PROJECT TITLE: ROBERTS OIL-LOMAS AND WASHINGTON

RE: ENGINEER CERTIFICATION FOR ROBERTS OIL @ LOMAS & WASHINGTON
(K17-D82) CERTIFICATION STATEMENT DATED 10/26/98

GRADING AND DRAINAGE PLAN

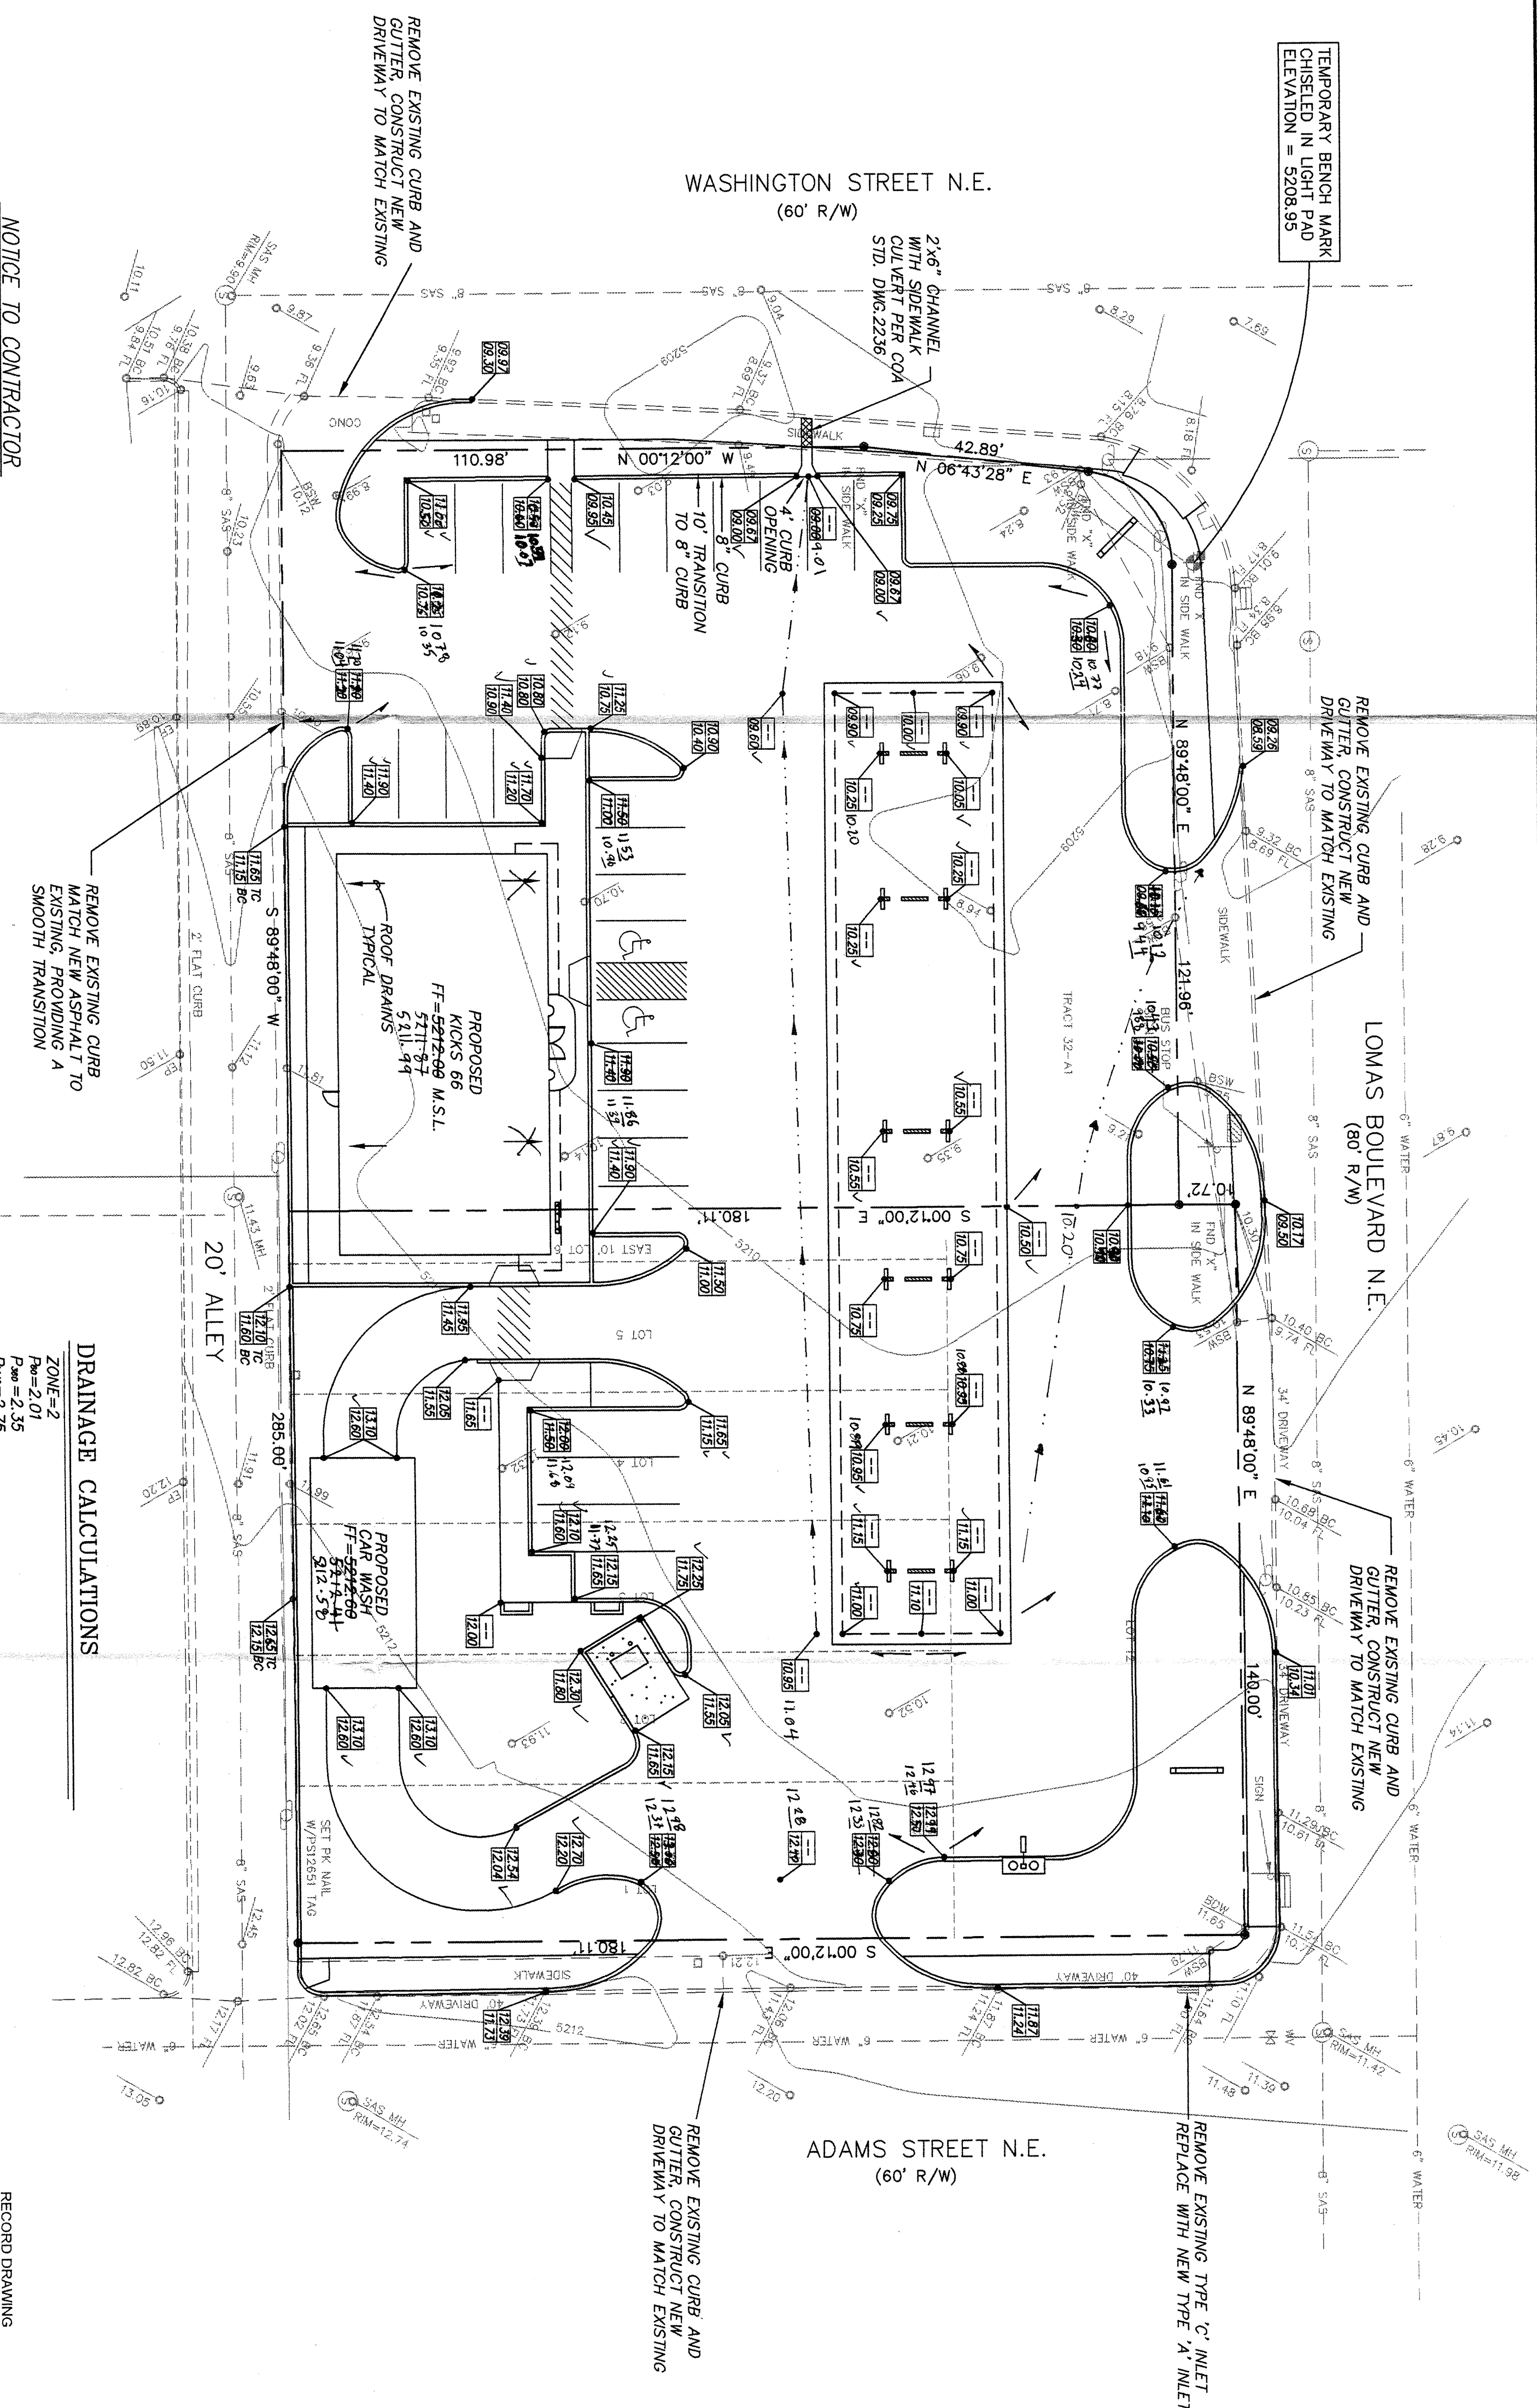
Based on the information provided on your October 27, 1998 submittal, Engineer Certification for the above referenced site is acceptable.
